# APPLICATION FOR PERMISSION UNDER SECTION 16 OF THE TOWN PLANNING ORDINANCE (CAP.131)

Section 16 Planning Application for a  
Comprehensive Non-domestic Redevelopment in  
“Comprehensive Development Area (1)” Zone for  
Enhancing Development Flexibility of the  
Approved Planning Application No. TPB/A/K14/745

**[E2022071J7] RE: S16 planning application No. A/K14/819 at DAs 4 & 5 of Kwun Tong Town Centre - Main Site**

**Re: S.16 Application for Development Areas 4 and 5 of**  
**Kwun Tong Town Centre – Main Site**  
**(Planning Application No. A/K14/819)**

**PROPOSED JUNCTION LAYOUT OF HONG NING ROAD /  
NGAU TAU KOK ROAD (J5)**

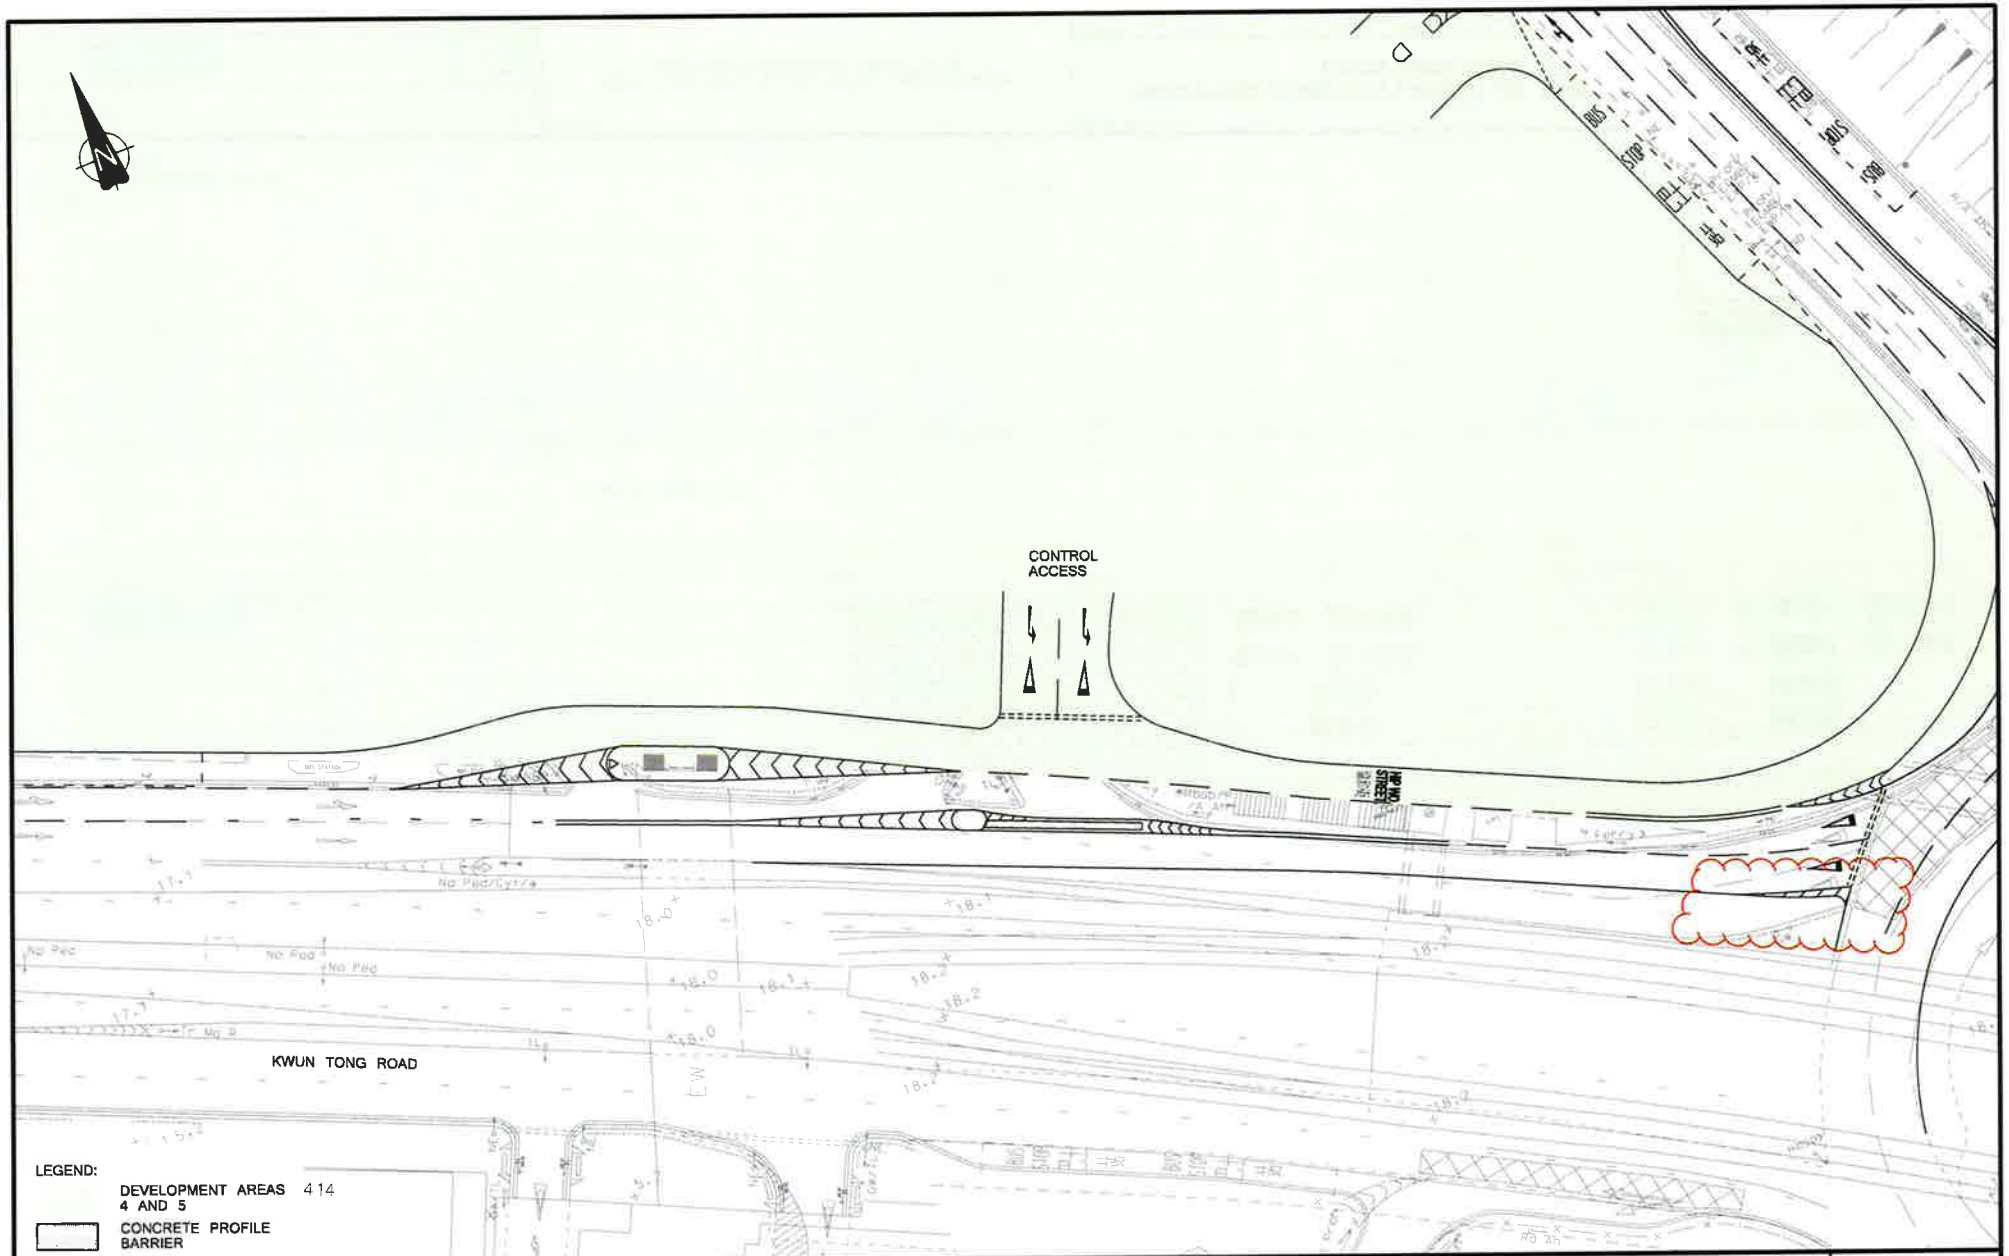
- (g) R-t-c (j) of 1<sup>st</sup> FI - Traffic lane lines should be added at yellow junction box to guide motorists.

SK B2

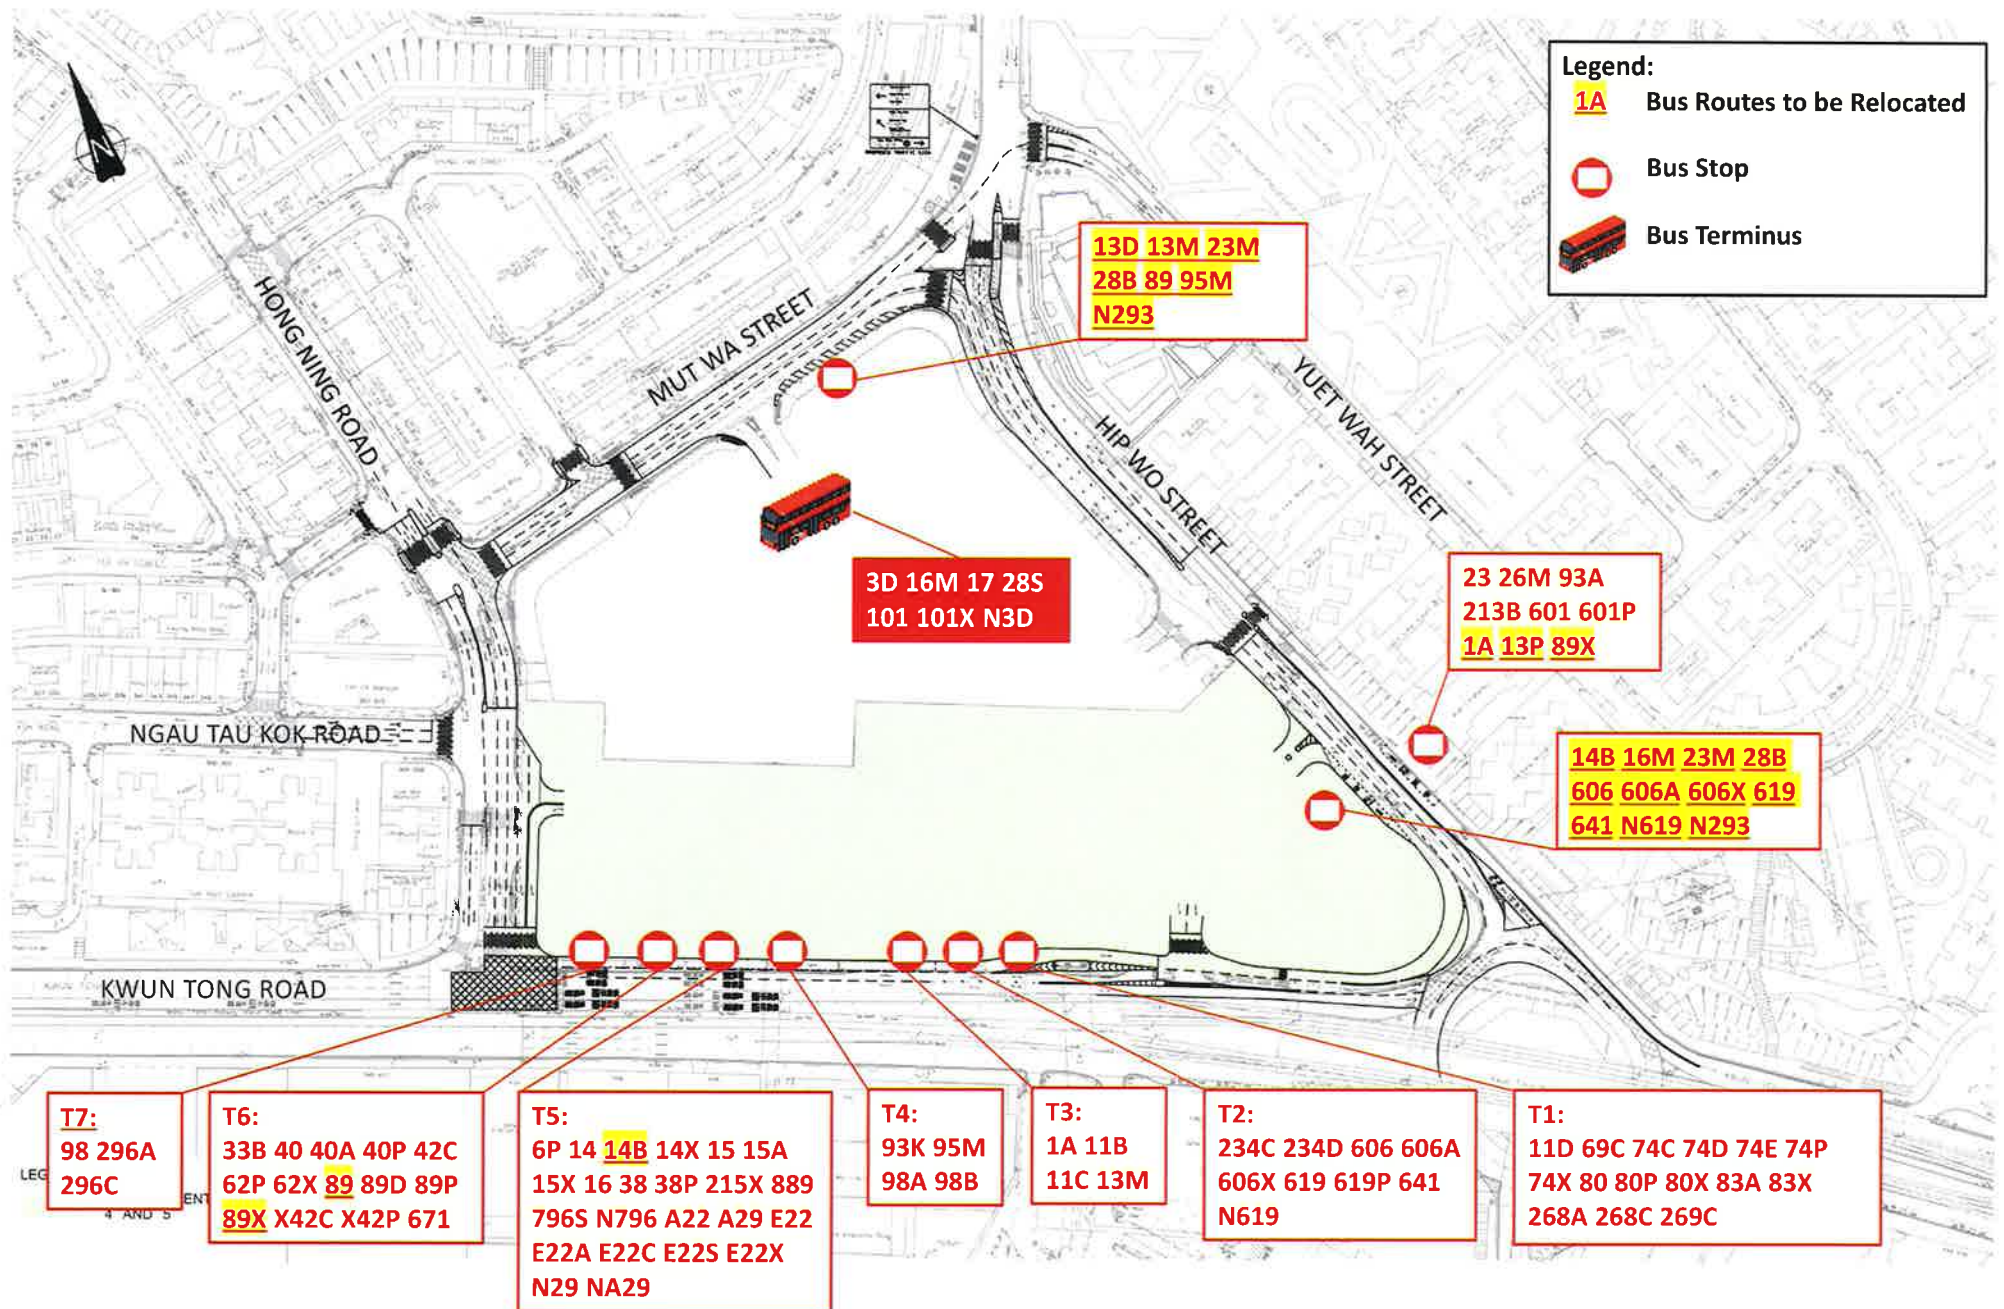
(2) Diagram SK B2	
- As per my previous comments, KMB Route No. 89B will be truncated to Ngau Tau Kok as per a settled RPP (route planning program) item of 2022/23. As a result, please remove 89B from the diagram.	Noted. The relevant information has been updated as shown in <b>SK B2</b> (please refer to <u>Annex 1</u> ).

(3) Diagram SK B2	
- Please note KMB Route No. 89B will be truncated to Ngau Tau Kok as per a settled RPP (route planning program) item of 2022/23.	Noted. The relevant information has been updated as shown in <b>SK B2</b> (please refer to <u>Annex 1</u> ).
